Section 16 Planning Application for Proposed Minor Relaxation of Plot Ratio Restriction for Permitted Flat Use (Proposed Amendments to an Approved Scheme with Minor Relaxation of Plot Ratio Restriction under Application No. A/H6/91) at 4, 4A, 4B and 4C Tai Hang Road, Hong Kong (Application No. A/H6/97)

Responses to Departmental Comments

Figure: 2.2a

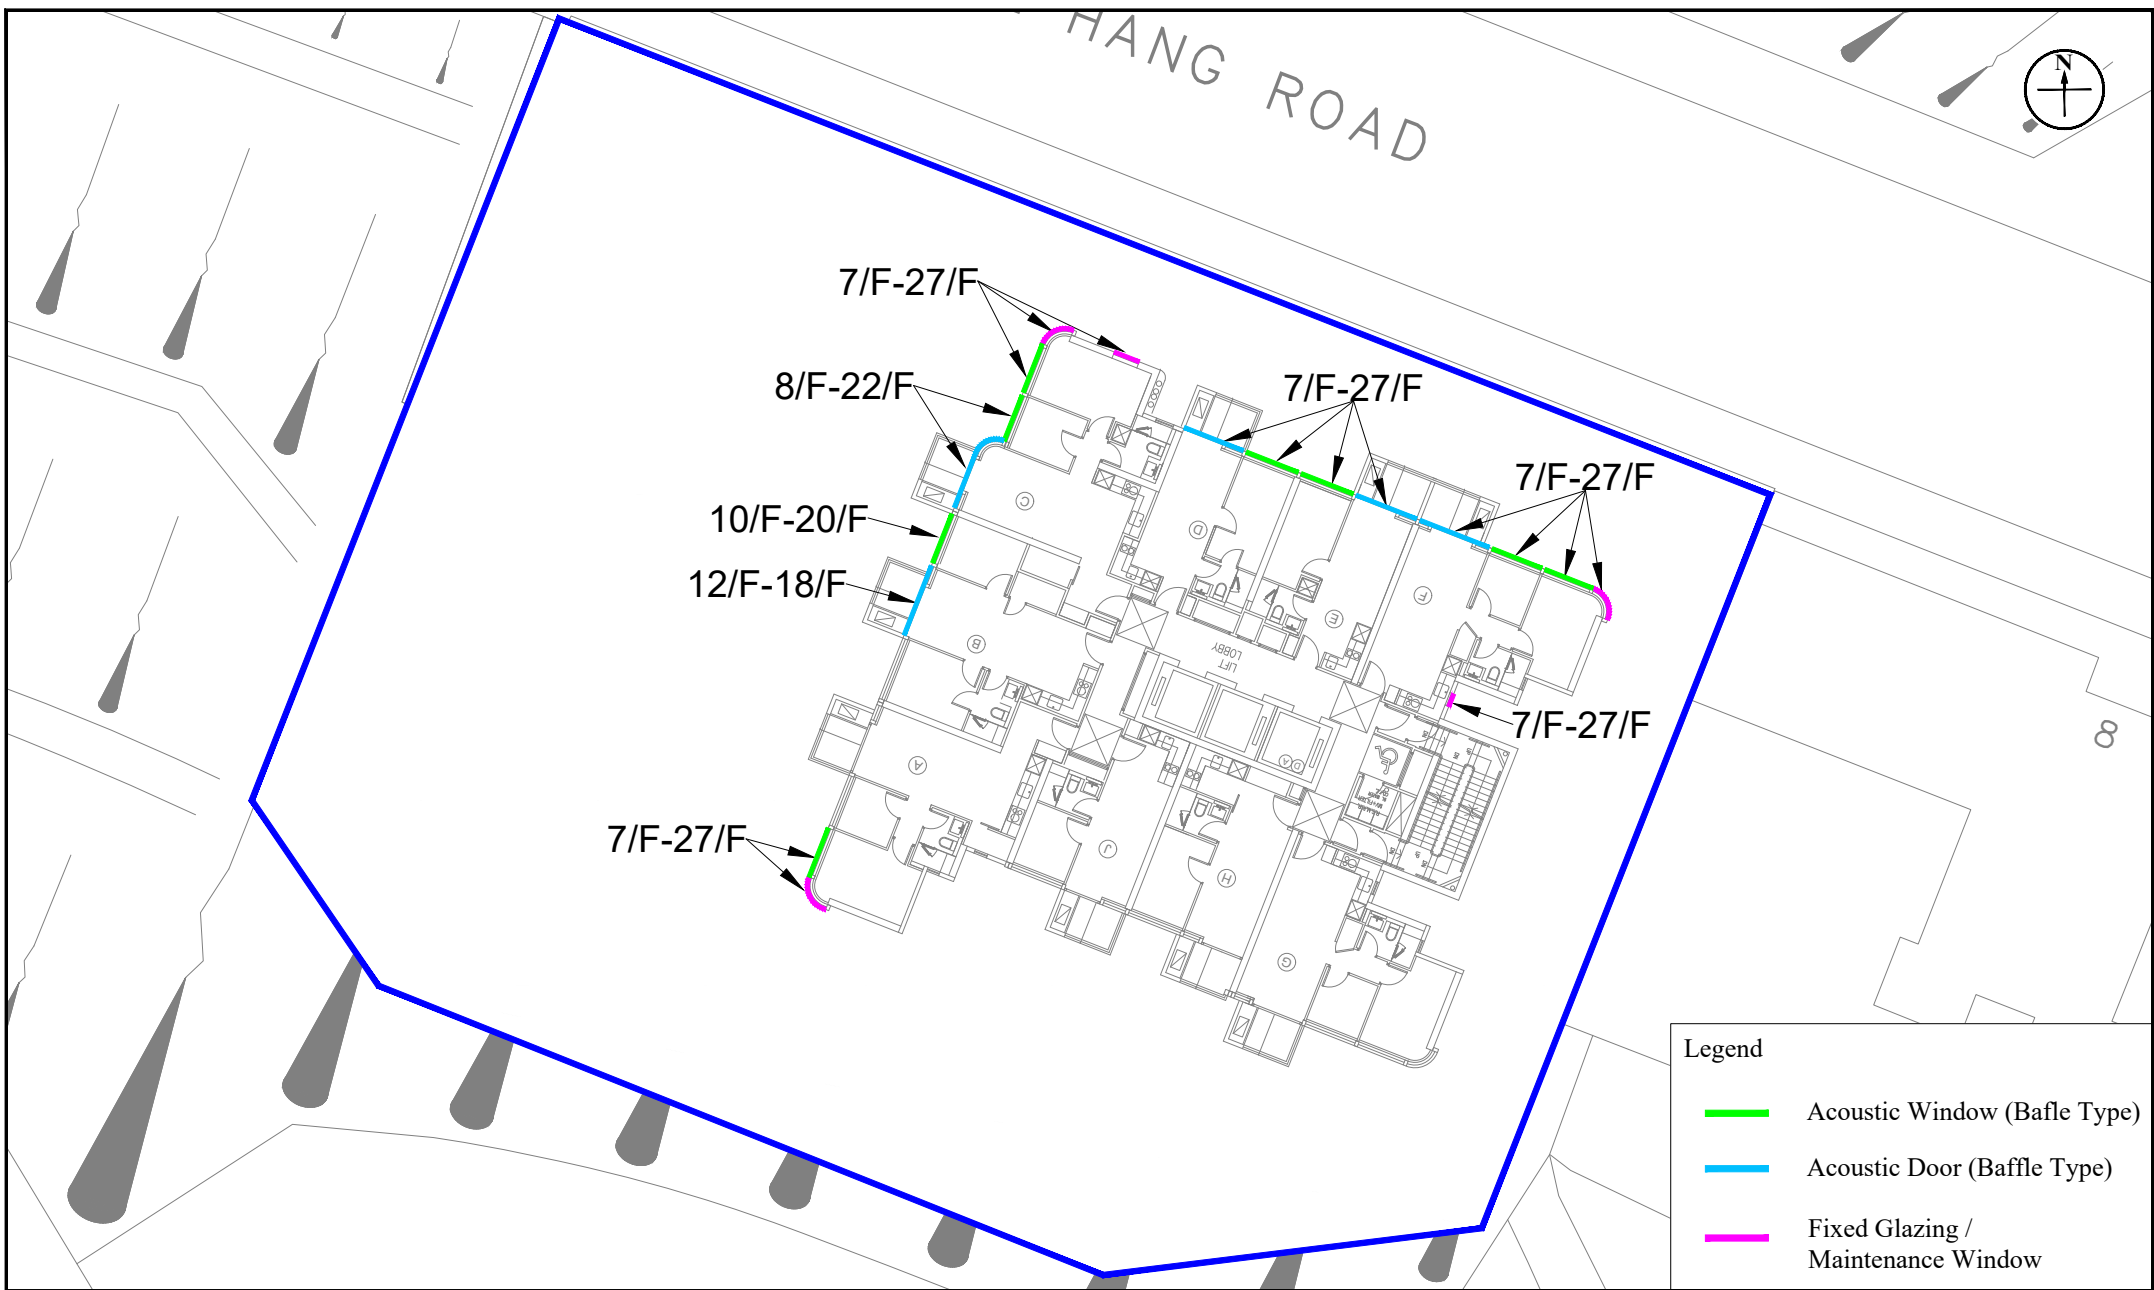
7.13	Figure 2.1a & 2.2a: The floor of figure title of 2.2a is inconsistent with 2.1a.	Noted. The title of Figure 2.2a of the EA under Attachment 3 has been revised accordingly.

Figure: 2.2b

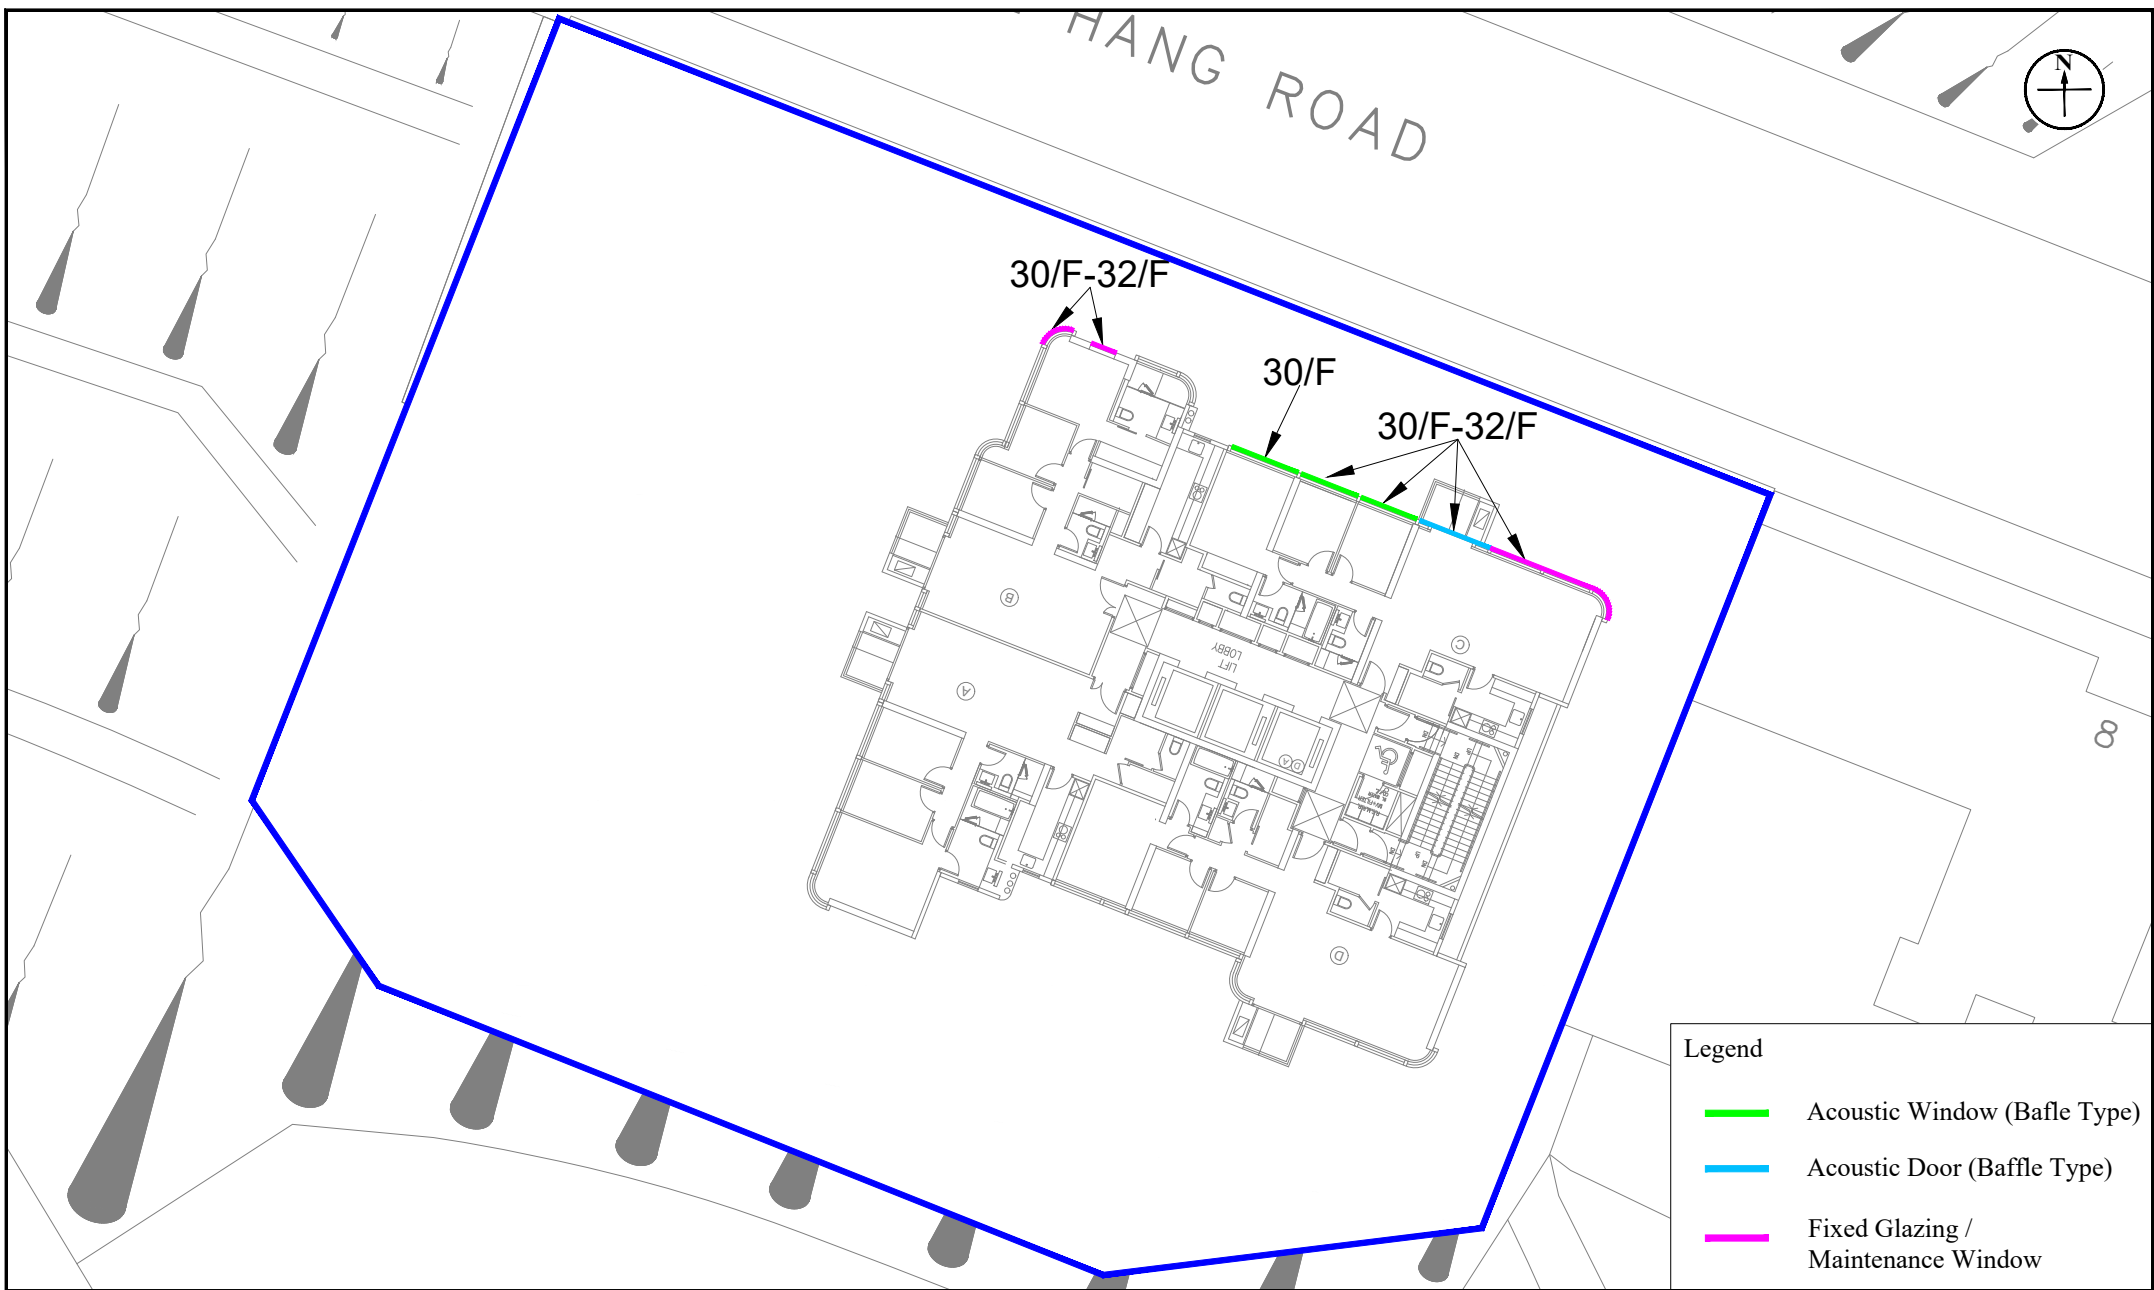
7.15	Figure 2.2b, Appendix 2-2 & 2-5: The mitigation measure for H-05 shown in Appendix 2-2 is inconsistent with Figure 2.2b and Appendix 2-5.	Noted. Appendix 2-2 of the EA under Attachment 3 has been revised accordingly.
